Revision to Permit Application – 40 Blairwood

Revision
Notes and
Plans

40 BLAIRWOOD DR

REVISION(A)

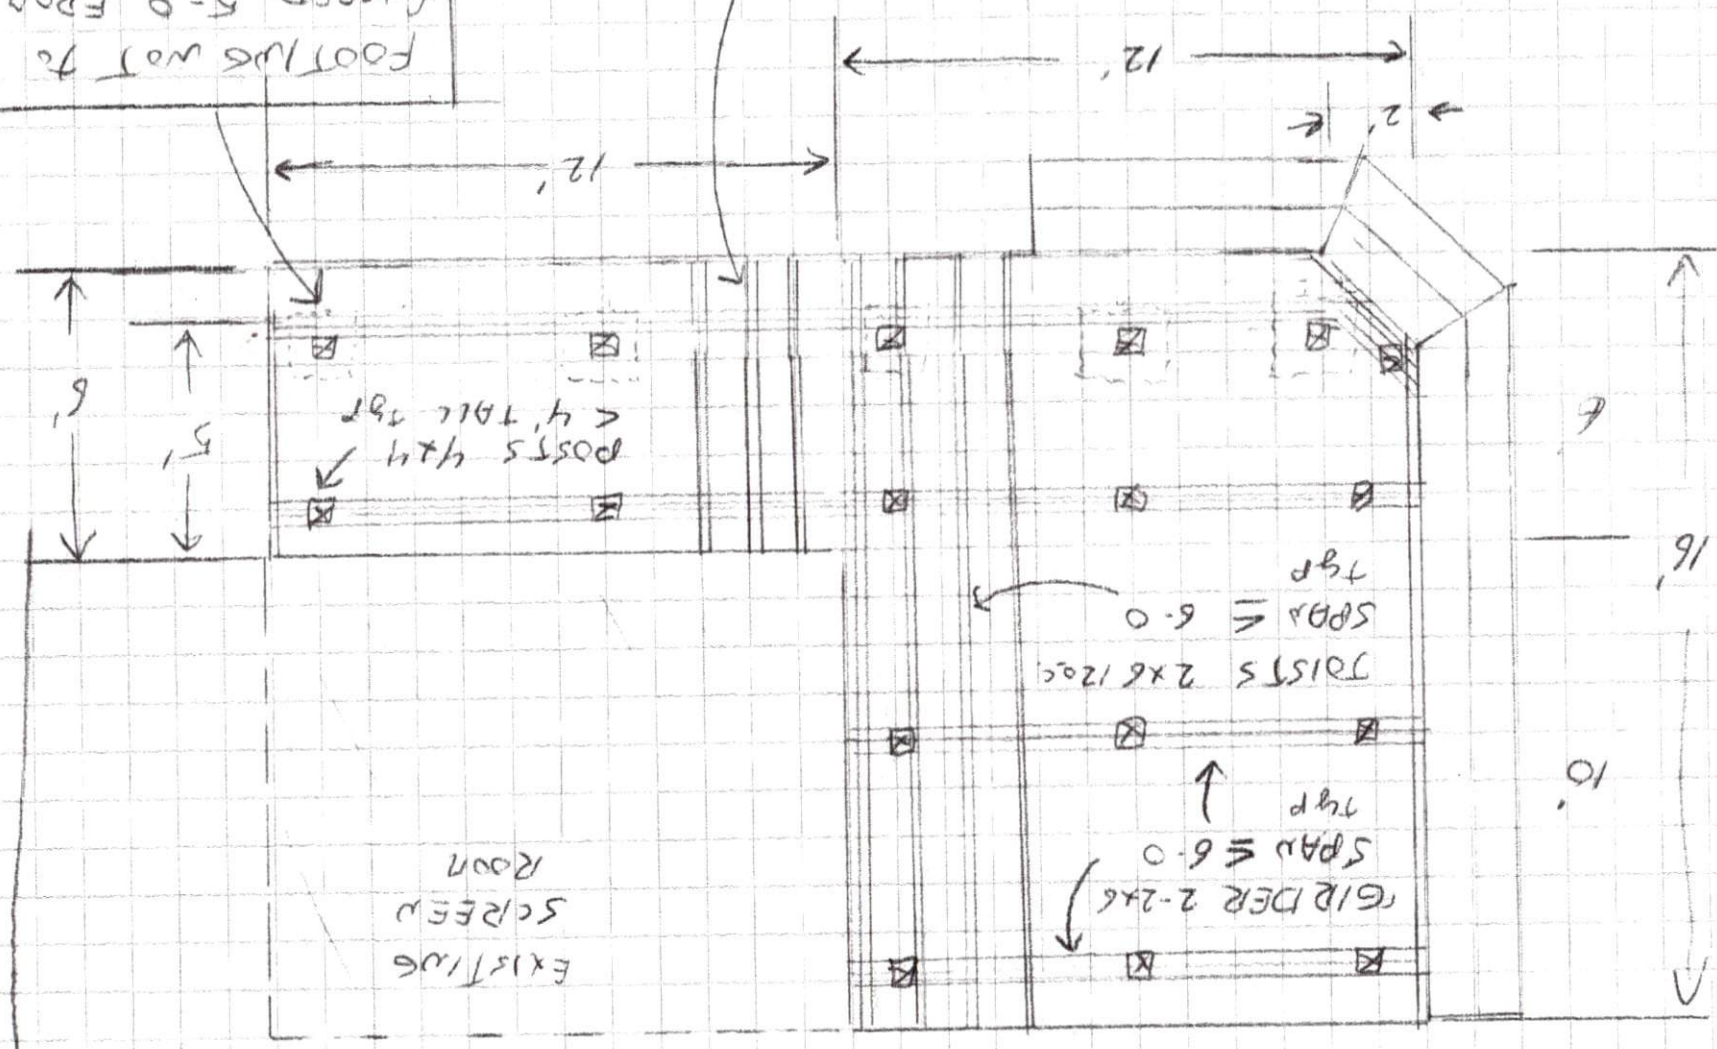
Jim at environmental requires the setback for the deck to be less than 5' from the screen room. The included revision to the original plans moves the outer beam footing to meet this requirement. 2 drawings are included to reflect this requirement, the main overall deck plan labeled "Revision A" and a detail of the footing location and cantilever labeled "Detail A"

The only change to the plan is the joist cantilever, footing location, and set max joist and beam span to 6' to accommodate the change in footing size.

The joist cantilever will be 10 ¾" with an adjacent joist span of 53 ¾"

The footing will be precast block 8" x 16" x 4" set at least 12" below grade, not to exceed 60" from N-E wall of existing screen room. Max Tributary area of the deck supports is 6' x 6'.

FOOTINGS NOT TO EXCEED 5'-0" FROM SCREEN PANEL N-L "DETAIL (A)" WALL - SEE PAGE

2x6 JOISTS CANTILER 18" SPAN BETWEEN BEAMS = 48"

- REVISION req'd → septic set back is 5' from N-E wall of existing screen room
- CHANGED FOOTING SIZE & LOCATION - to meet set back -
